2004 - 2009 Cadillac XLR: Service Bulletin: #01-07-30-032E: Transmission Oil Leaking From Transmission Vent

#01-07-30-032E: Transmission Oil Leaking From Transmission Vent (Replace Transmission Case Cover (Channel Plate) Gasket) - (Sep 29, 2008)

Models: 1997-2009 GM
Passenger Cars and
Light Duty Trucks
(including Saturn)

with Hydra-Matic
4T65-E Automatic
Transmission (RPOs
MN3, MN7, M15, M76)

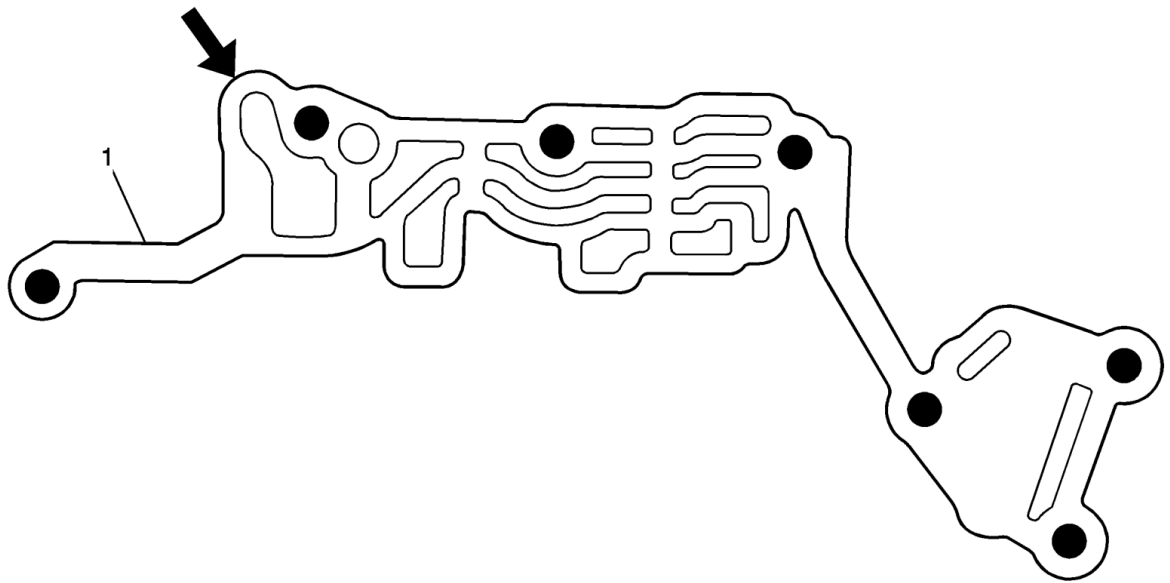
This condition may be caused by an improperly torqued channel plate gasket.

Visual inspection of the upper gasket (1) will reveal damage at the referenced area.

To correct this condition, replace the case cover (channel plate) gaskets (429 and 430). Refer to Unit Repair publication in SI of the appropriate vehicle being serviced.
